Access Compliance Report

Public Rights-of-Way

(Curb Ramps)

Intersection ID: 20949	Main Street: BRICKER_DR	Cross Street: CEDAR_RUN_WY	Location:	N
ADA ID: 2EFF7BAD5445	Ramp Type: PerpDiag	Initial Pass/Fail: Fail	Overall Compliance: No	Severity Score: 13.75
Codes/Mitigation Info/Possible Solution		Field Measurements/Component Compliance

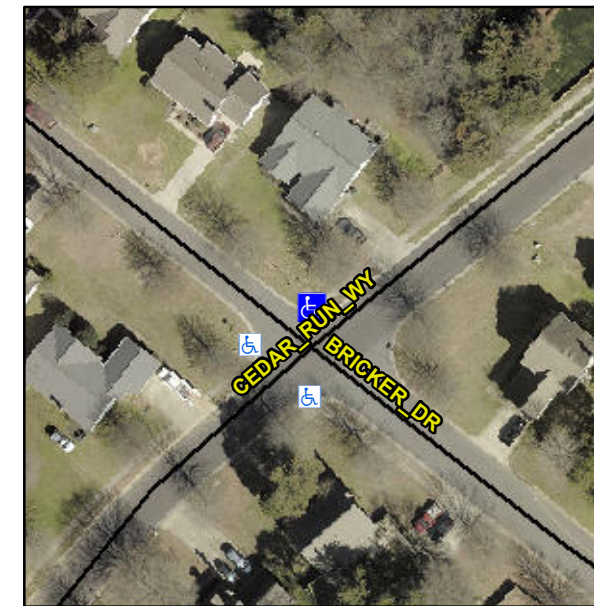
Not Found, R304.2.2, R304.5.3

Compliance	Description	Data	Compliance	Description	Data
N/A	Ramp Length (in)	48.0	No	Ramp Slope (%)	8.4
Yes	Ramp Width (in)	48.0	No	Ramp XSlope (%)	2.4
N/A	Flare Type LT	N/A	N/A	Flare Type RT	N/A
N/A	Flare Slope LT (%)	N/A	N/A	Flare Slope RT (%)	N/A
N/A	Flare Traversable LT?	N/A	N/A	Flare Traversable RT?	N/A
N/A	Landing Length (in)	N/A	N/A	DWS Provided?	N/A
N/A	Landing Width (in)	N/A	N/A	DWS Contrast?	N/A
N/A	Landing Slope (%)	N/A	N/A	DWS Length (in)	N/A
N/A	Landing X Slope (%)	N/A	N/A	DWS Full Width?	N/A
N/A	Landing Curb? (Y/N)	N/A	N/A	DWS Offset (in)	N/A
N/A	Shared Landing?	N/A			
N/A	Gutter Ponding?	N/A	N/A	Gutter Slope (%)	N/A
N/A	Gutter Lip Ht (in)	N/A	N/A	Gutter X Slope (%)	N/A
N/A	Painted X Walk1?	No	N/A	Painted X Walk2?	No
	X Walk 1 Direction	To SW		X Walk 2 Direction	To SE
N/A	X Walk 1 Width (in)	N/A	N/A	X Walk 2 Width (in)	N/A
	X Walk 1 Slope (%)	1.9		X Walk 2 Slope (%)	0.3
	X Walk 1 X Slope (%)	2.1		X Walk 2 X Slope (%)	3.1

Remove & Replace Curb Ramp With Two New Directional Ramps or Equivalent.
